Full submissions names only - Jeffreys replacement water tank alternative option
See bottom of document for attachments

Subject: Proposed Council water storage tank in Jeffreys Park

Graphic Attachment

Aerial photograph – showing the Anderson's preferred option

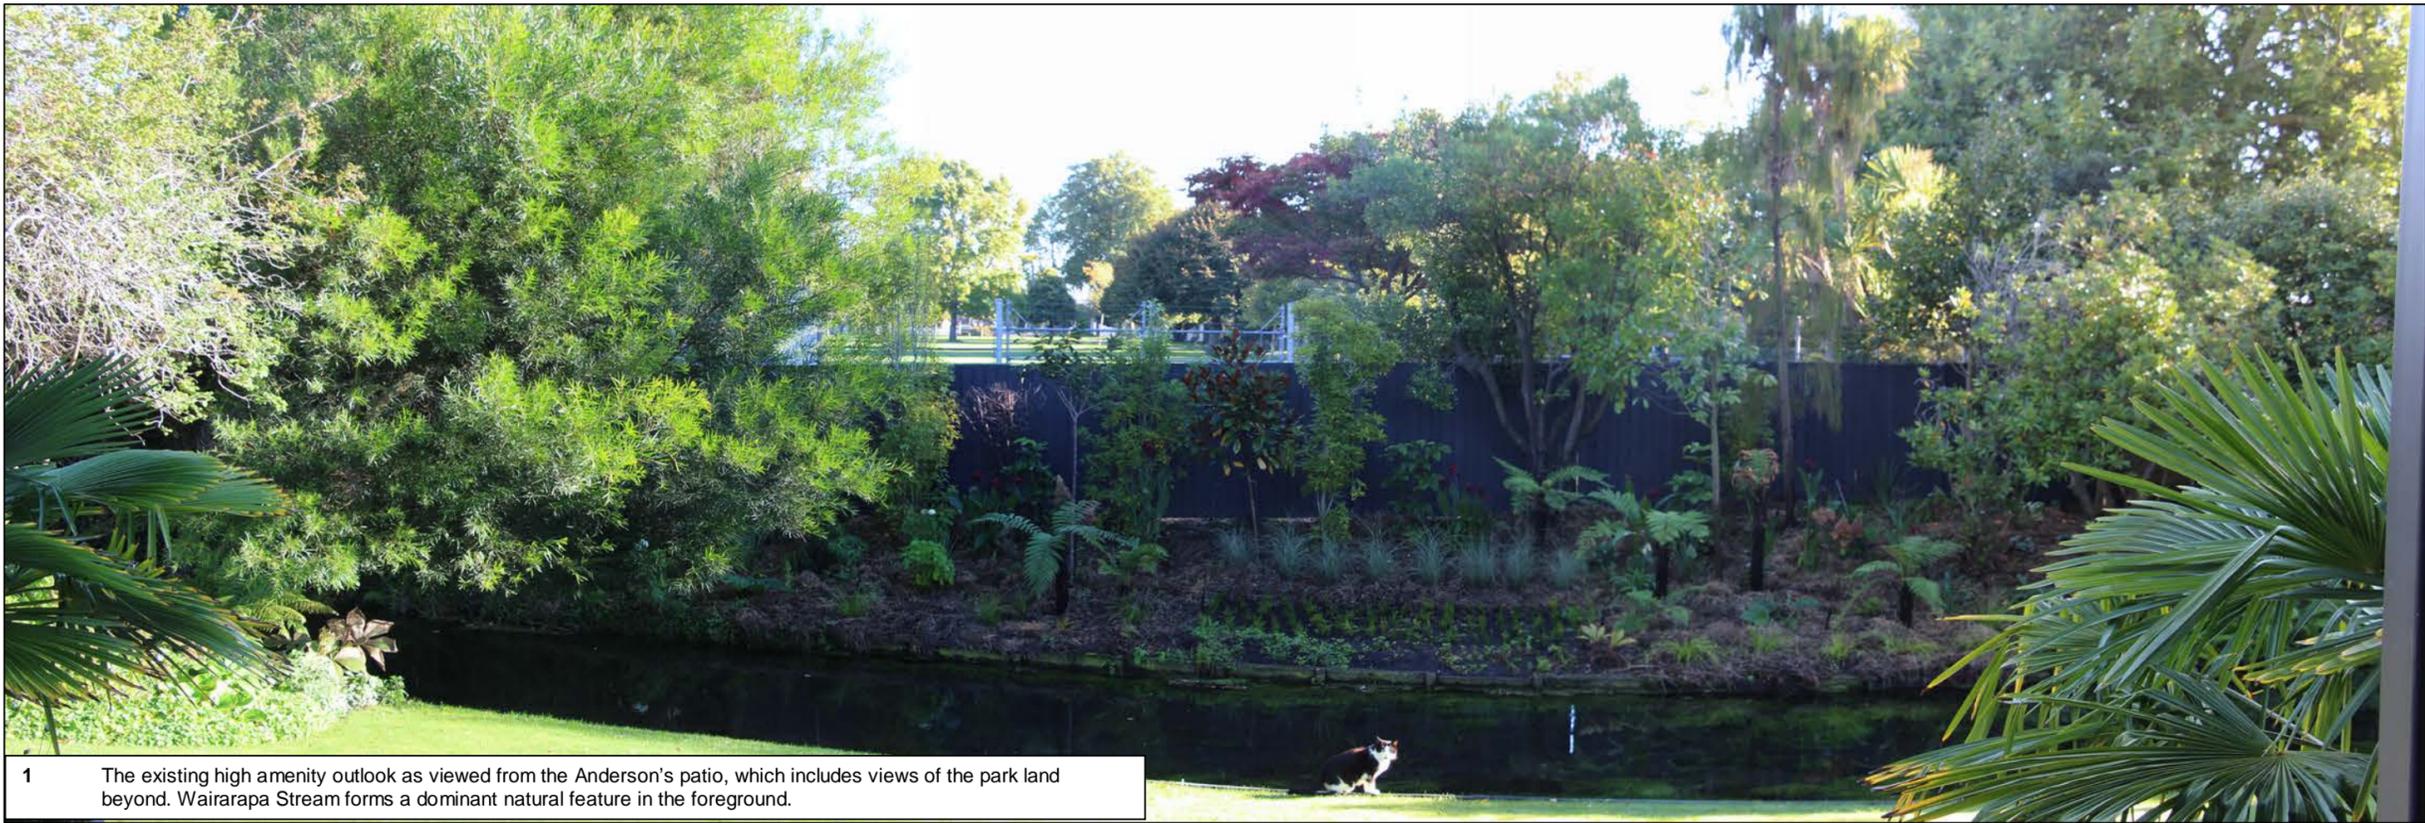
The tanks' form and bulk would in fact better integrate with existing structures elsewhere in the park where they occur away from residential neighbours – namely in the vicinity of the tennis court or service centre. Here it would be read as being part of a cluster of structures understood to provide public service.

Based on the foregoing discussion, it is my opinion that the Option 2 tank location is not the best means of minimising adverse amenity effects. Other options are available which would minimise and avoid amenity effects, namely those located in the vicinity of the tennis court. The Anderson's preferred option is one that locates the tank on the south side of the tennis court – see the Appendix 1 aerial photograph. But in my opinion any option that locates the tank north of here would better achieve minimisation of effects.
